MIDLAND UNITS 1 & 2
JOB NO. 7220

REVIEW OF U.S. TESTING
FIELD AND LABORATORY CONSTRUCTION
TEST DATA ON SOILS USED AS FILL

PREPARED BY
BECHTEL POWER CORPORATION
JUNE 12, 1979

FIG. 81

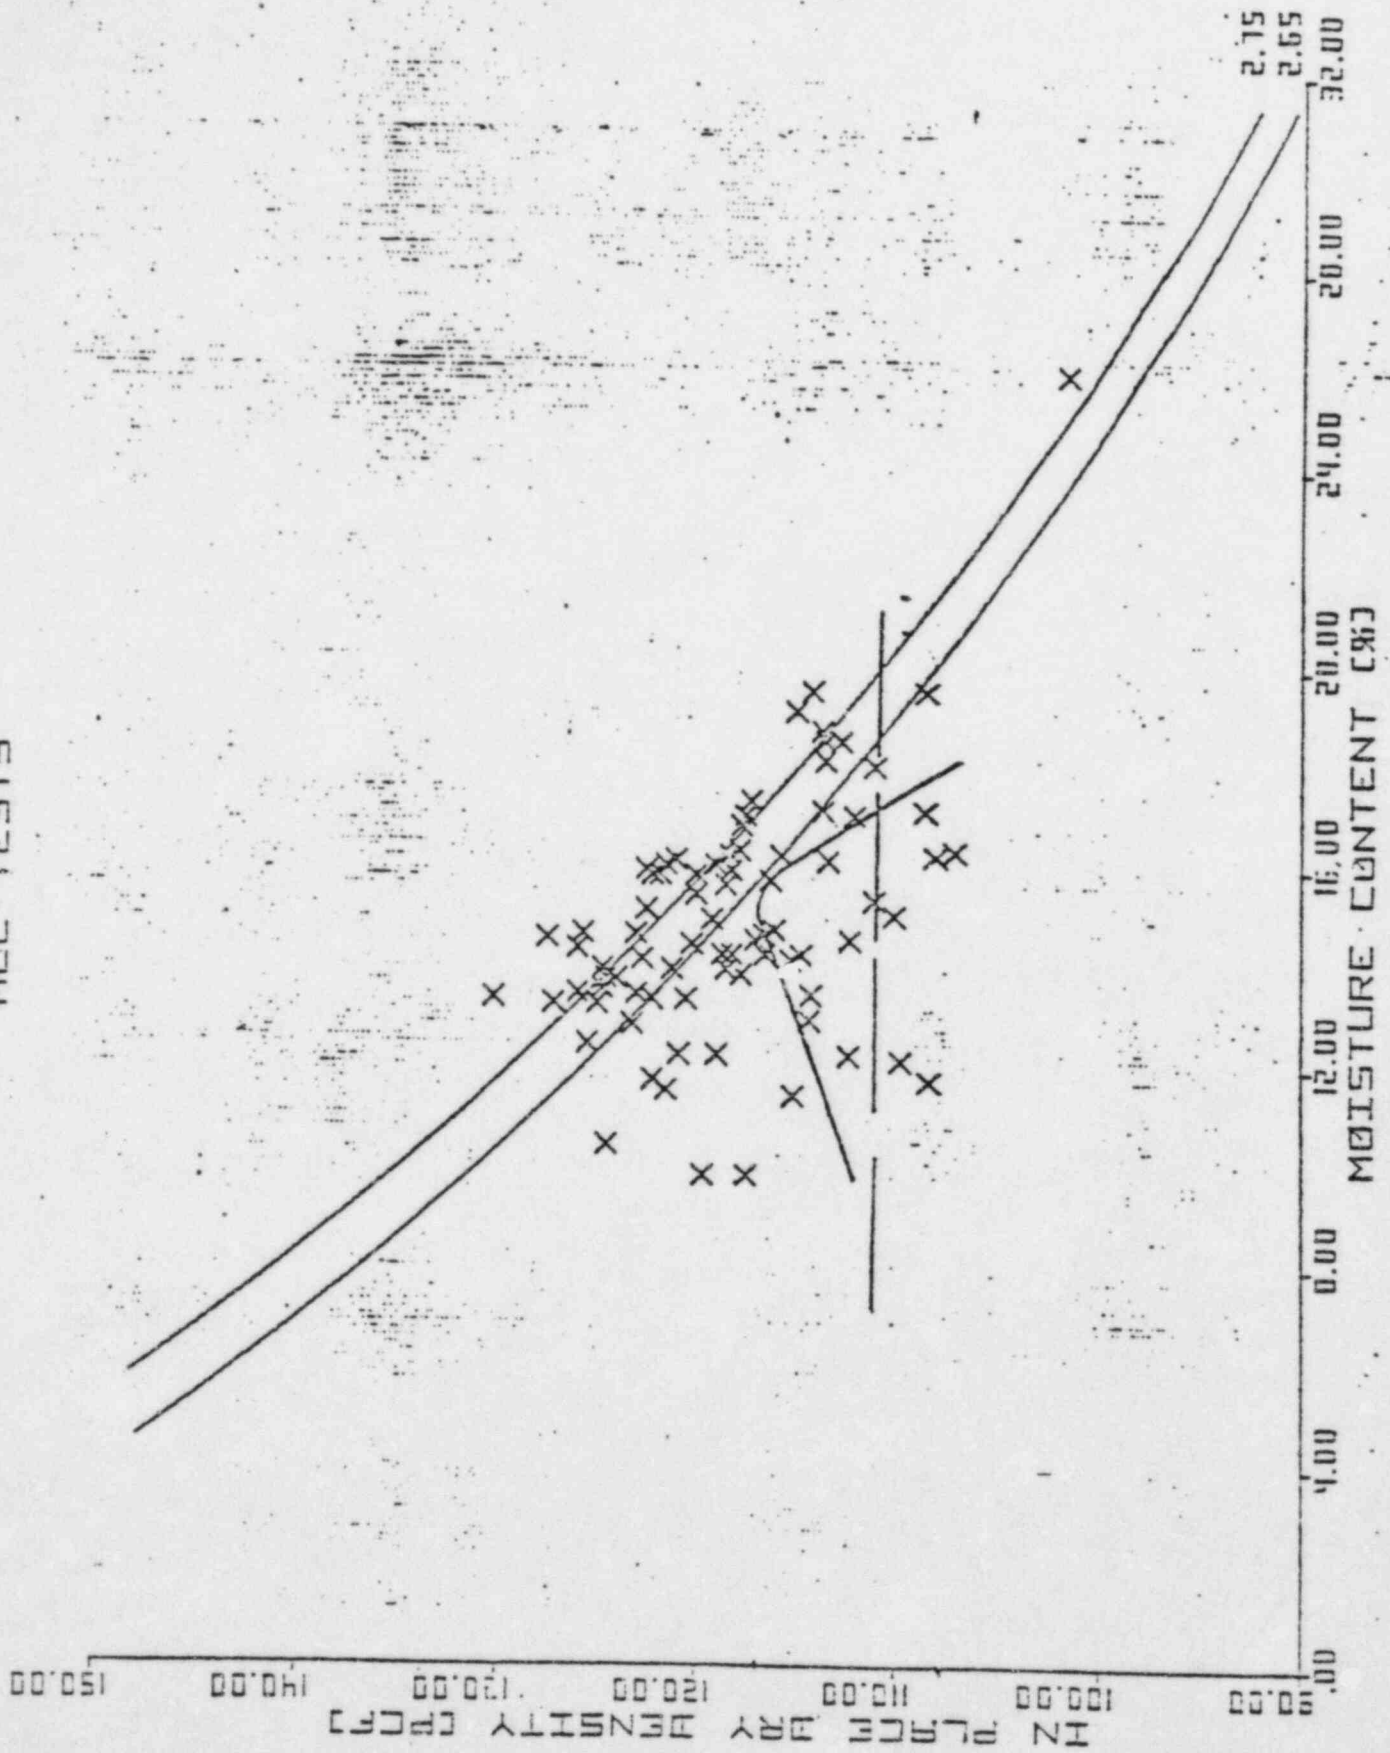
Also referring to figure 1 it would appear that soil density varied widely or that compactive effort varied widely. Specifications called for compactive effort results as defined by ASTM D 1557 which is slightly over 56,000 ft-lb/ft³ energy. This was modified to a laboratory test compactive effort of about 20,000 ft-lb/ft³ energy, ^{often} ~~hereafter~~ referred to as Bechtel Modified Proctor (BMP). Laboratory compaction test curves should be related to the same effort as that called for in the field for use in comparing with field density tests. According to plots of field data shown on Figure 1, density varied from about 108 lbs/ft³ to about 130 lbs/ft³. It is doubtful that the soil classification or ^{other} properties would be similar for such a wide variation in density. It is noted that 100 percent of modified Proctor (ASTM D 1557) which is difficult to obtain, is rated at slightly over 56,000 ft-lb/ft³ energy. The curve plotted on Figure 1 is at about 20,000 ft-lb/ft³ energy. For comparative purposes it was determined by ^{H. S. Testing} ~~Bechtel~~ in 1974 that 100 percent of specified effort (20,000 ft-lb/ft³) is approximately equal to ⁹⁵ ~~65~~ percent of the maximum density as determined by ASTM D-1557 (56,255 ft-lb/ft³). ^{Ref. Fig. 1} This means that a density up to ⁵ ~~8~~ percent greater (dry density of ^{123.2} ~~117.0~~ lbs/ft³) than that specified (dry density of 117.0 lbs/ft³) could be possible. However, some points shown on Figure 1 give an apparent density up to 11 percent above that specified.

FIGURE 7-A-

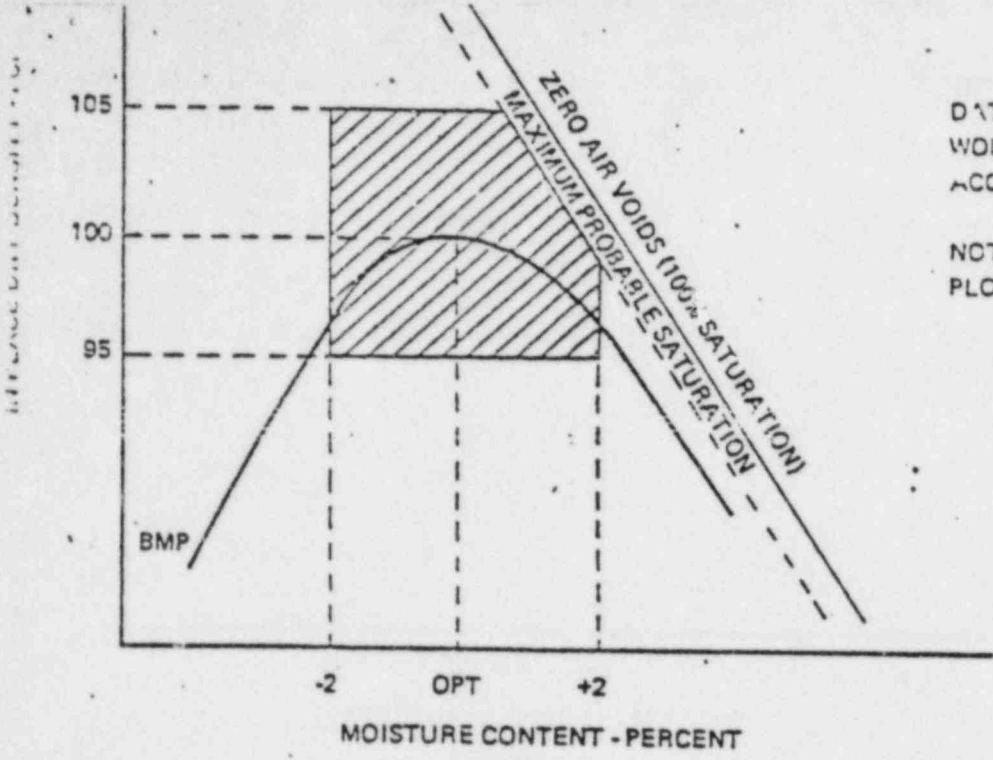
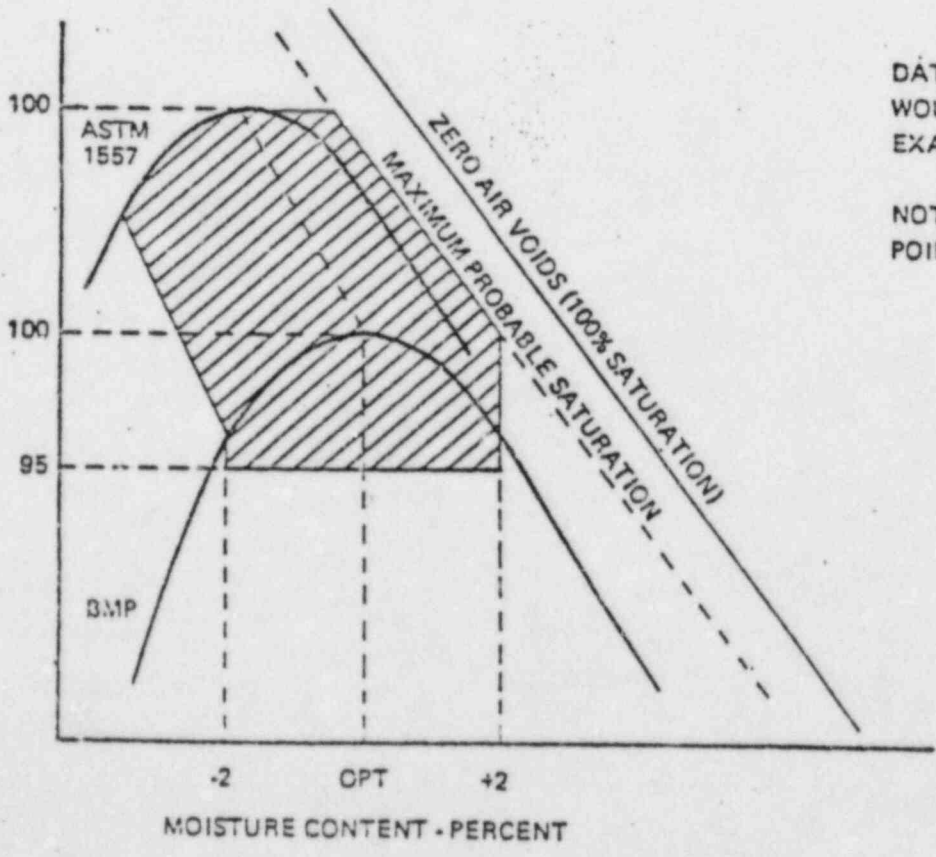
For a field test result to be classified as "Passing" it must fall within a well defined area on the plot containing the laboratory compaction curve. This area or window of acceptability is shown for a hypothetical compaction curve on figure 7^a that would meet requirements of Specification 7220-C-210. It is defined by horizontal lines at 95 percent and 105 percent of specified density, vertical lines through ± 2 percent of optimum moisture content, and a line parallel to the zero air voids line indicating saturation about half way between the compaction curve and 100 percent ^{saturation} (zero air voids curve). If all data points fall within this area there would be no reason to assume that they are wrong. However, when many data points fall outside the designated area there is something wrong with the information and then all data points become suspect. A review of all data indicates that only about 25 percent of the ^(cohesive soil) test results fall within this area.

Figure 7b shows an area where field test results would be acceptable even though not in strict accordance with the specifications. Figure 7b was arrived at by expanding figure 7a to include test results up to a compactive effort related to ASTM D 1557 (56, 255 ft.-lbs./ft.³) which is considered to be a practical upper limit. About 40 percent of all field test results would plot in this area.

DATA POINTS THAT PLOT IN SHADED AREA WOULD BE GENERALLY ACCEPTABLE ACCORDING TO SPECIFICATIONS

NOTE: ABOUT 25% OF ALL FIELD DATA PLOTS IN THE SHADED AREA

DATA POINTS THAT PLOT IN SHADED AREA WOULD BE ACCEPTABLE REGARDLESS OF EXACT SPECIFICATION WORDING

FIGURE 1

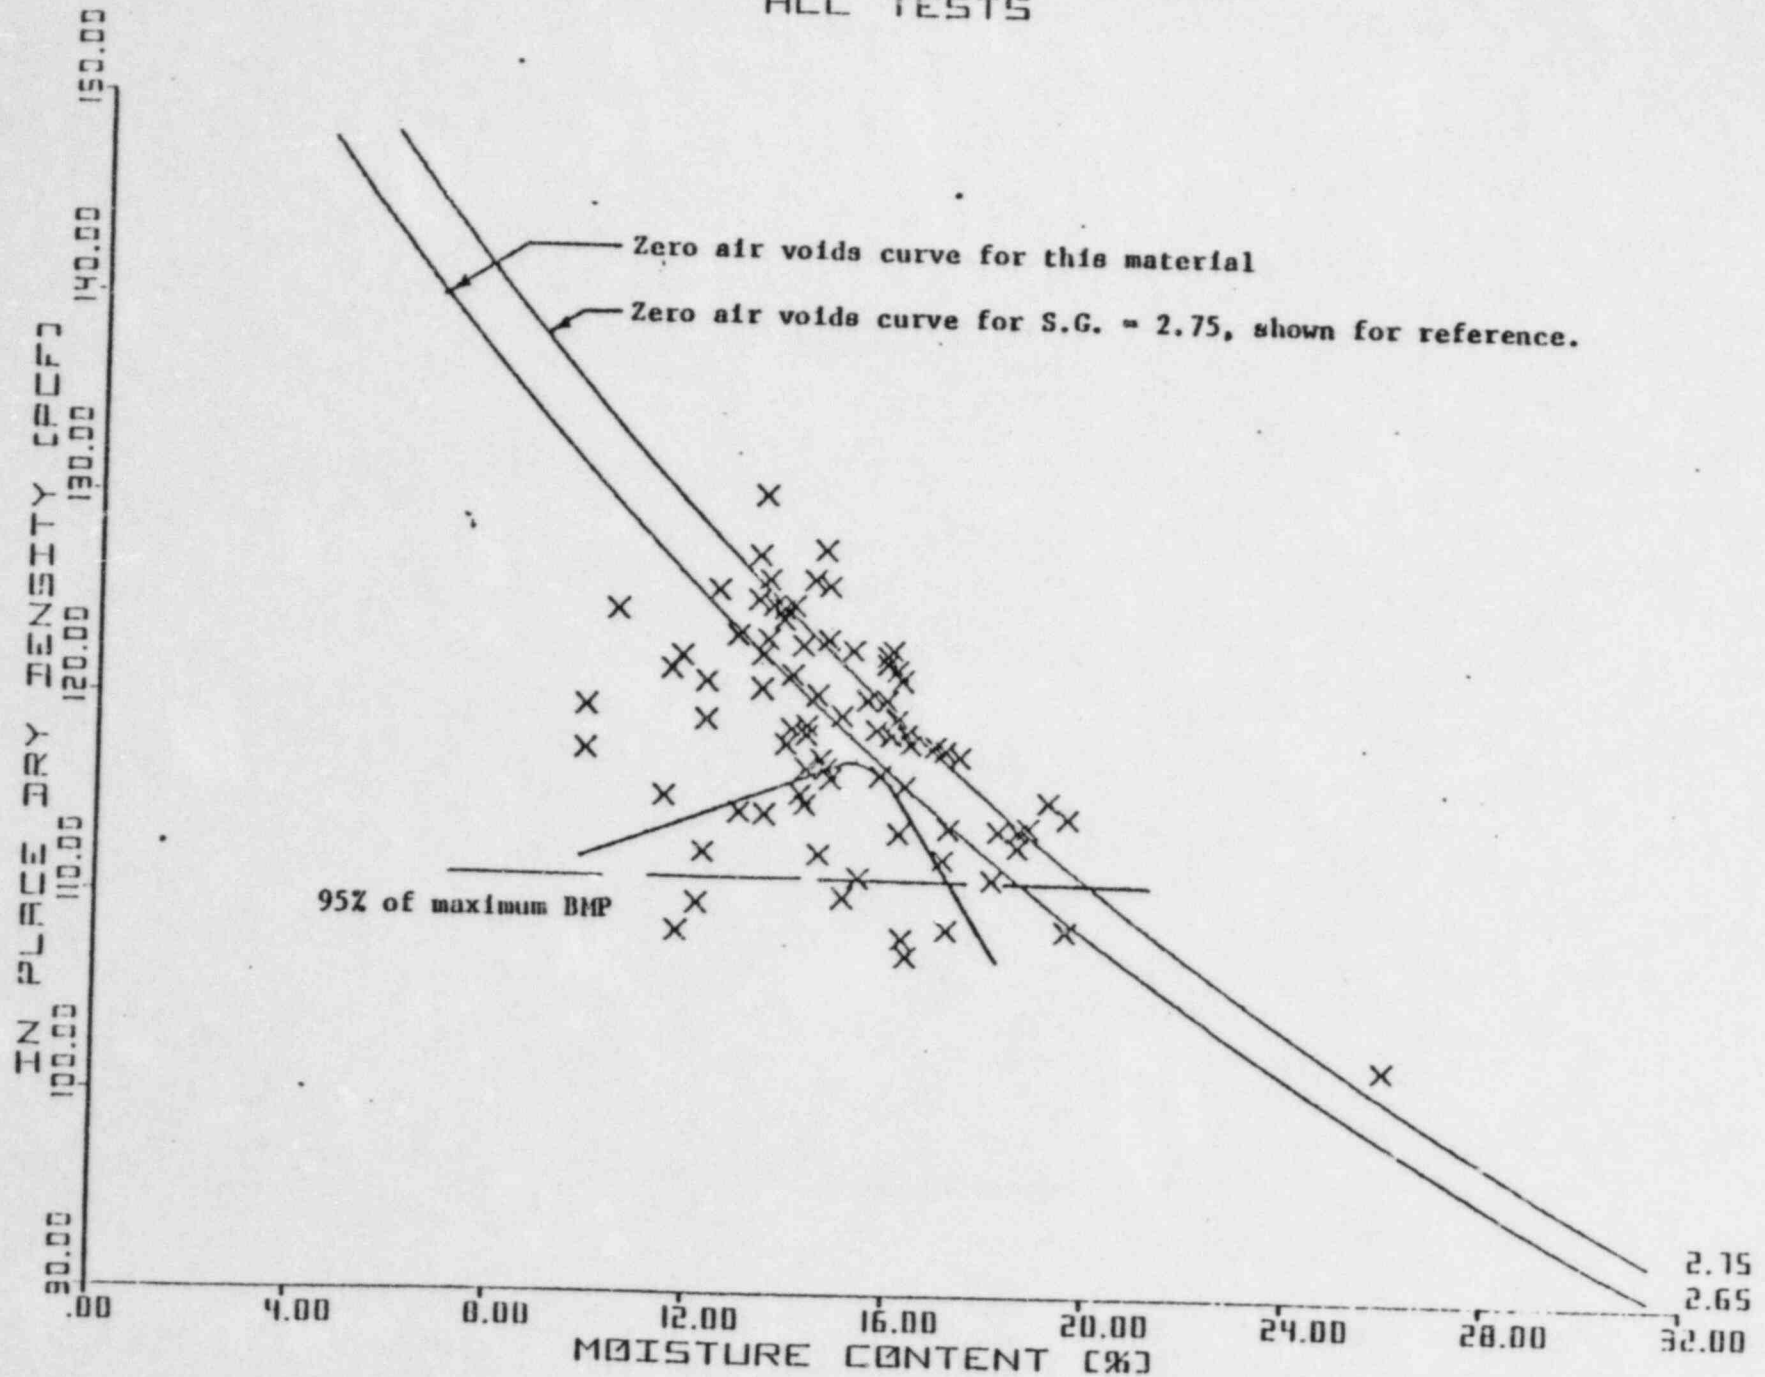
Also, referring to Figure 1 it would appear that soil density varied widely. Specifications called for compactive effort results as defined by ASTM D 1557 which is 56,255 ft-lb/ft³ energy. This was modified to a laboratory test compactive effort of about 20,000 ft-lbs/ft³ energy, often referred to as Bechtel Modified Proctor (BMP). Laboratory compaction test curves should be related to the same effort as that called for in the field for use in comparing with field density tests to determine percent compaction. According to plots of field data shown on Figure 1, density varied from about 108 lb/ft³ to about 130 lb/ft³. It is doubtful that the soil classification or other properties would be similar for such a wide variation in density. It is noted that 100 percent of modified Proctor (ASTM D 1557) which is difficult to obtain, is rated at 56,255 ft-lb/ft³ energy. The curve plotted on Figure 1 is at about 20,000 ft-lb/ft³ energy. For comparative purposes it was determined by U. S. Testing in 1974 that 100 percent of specified effort (20,000 ft-lb/ft³) is approximately equal to 95 percent of the maximum density as determined by ASTM D 1557 (56,255 ft-lb/ft³) Reference Figure 8.

FIGURE 7: WINDOWS OF ACCEPTABILITY (A) BASED ON BMP SPECIFICATION (B) REGARDLESS OF EXACT WORDING OF SPECIFICATION

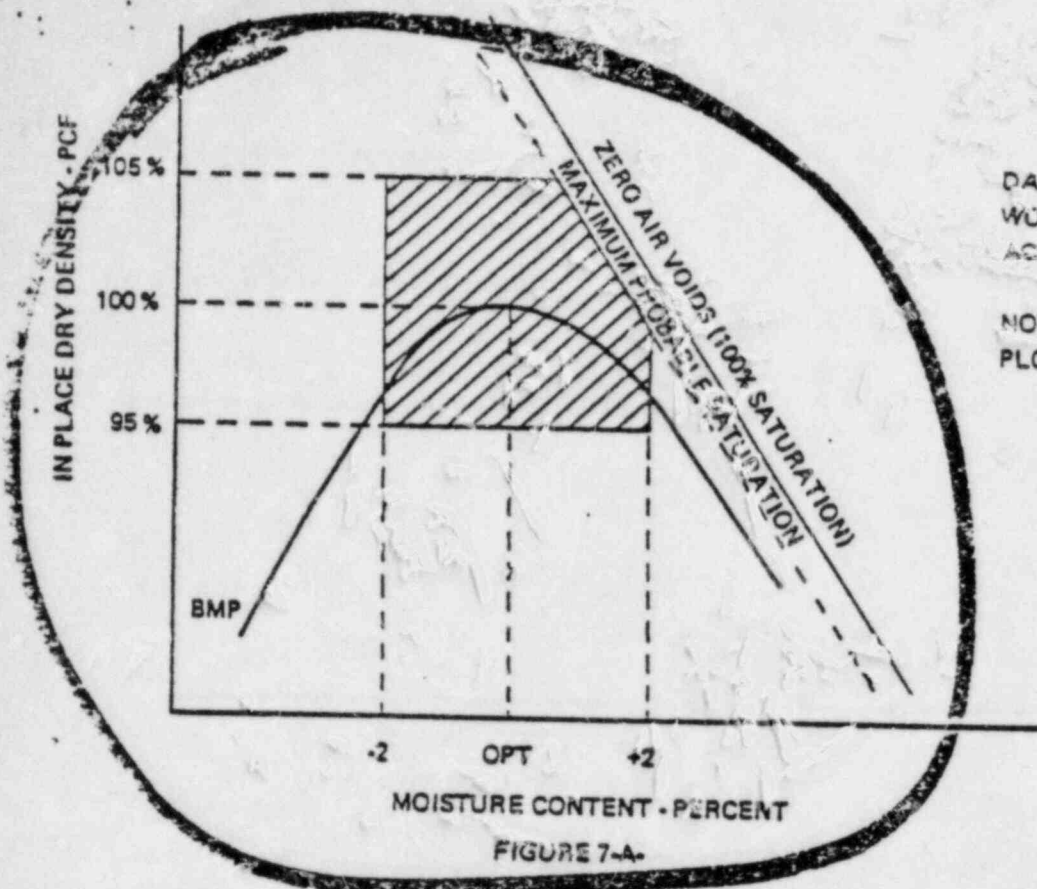
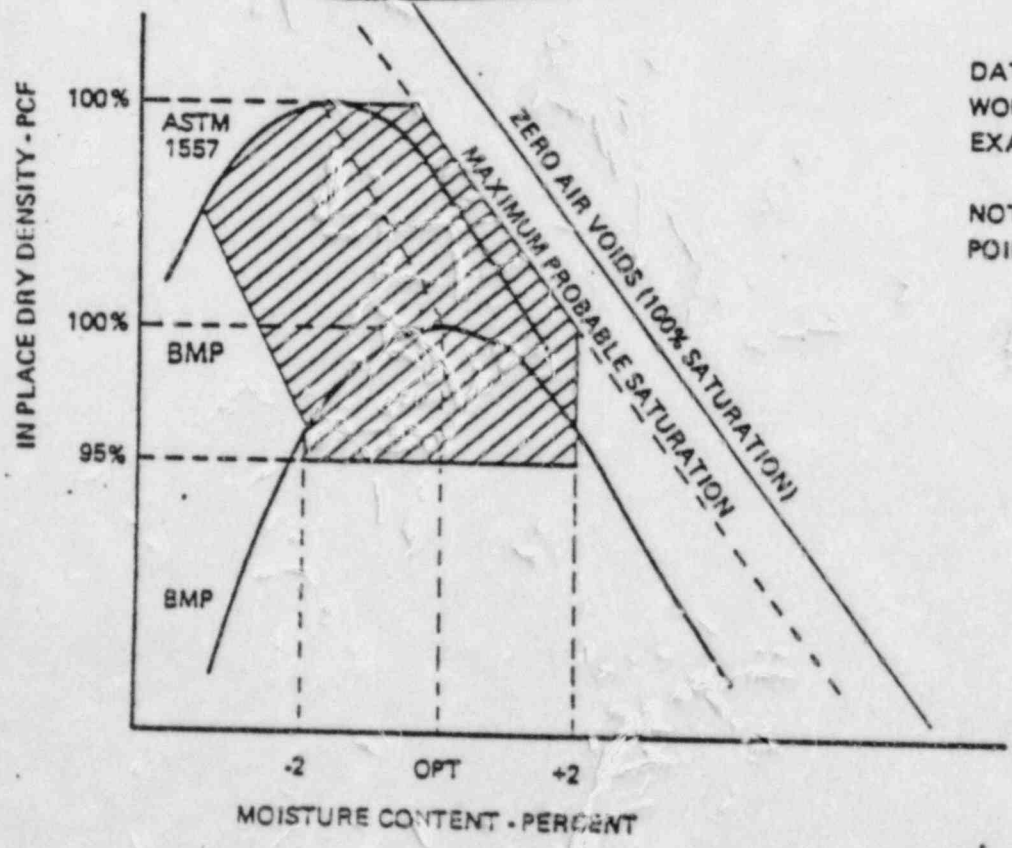
NOTE: For a field test result to be valid as well as "Passing" it must fall within a well defined area on the plot containing the laboratory compaction curve. This area or window of acceptability is shown for a hypothetical compaction curve on Figure 7a and would meet requirements of Specification 7220-C-210. It is defined by horizontal lines at 95 percent and 105 percent of specified density, vertical lines through ± 2 percent of optimum moisture content, and a line parallel to the zero voids line indicating saturation about half way between the compaction curve and 100 percent saturation (zero air voids curve). The practical upper limit of 105 percent of specified density is not defined in the specifications. It was arbitrarily chosen as numbers greater than this are increasingly invalid comparisons between test results and the specified laboratory compaction test curve. Therefore, if all data points fall within the defined window there would be no reason to assume that they are wrong. However, when many data points fall outside the designated area there is something wrong with the information and then all data points become suspect. A review of all data indicates that about 25 percent of the cohesive soil test results fall within this area.

Figure 7 shows an area where field test results would be acceptable, in theory even though not in strict accordance with the specifications. Figure 7B was arrived at by expanding Figure 7a to include test results up to a compactive effort related to ASTM D 1557 (56,255 ft-lb/ft³) which is considered to be a practical upper limit. About 40 percent of all cohesive soil test results would plot in this area.

DATA POINTS THAT PLOT IN SHADED AREA WOULD BE GENERALLY ACCEPTABLE ACCORDING TO SPECIFICATIONS

NOTE: ABOUT 25% OF ALL FIELD DATA PLOTS IN THE SHADED AREA

DATA POINTS THAT PLOT IN SHADED AREA WOULD BE ACCEPTABLE REGARDLESS OF EXACT SPECIFICATION WORDING
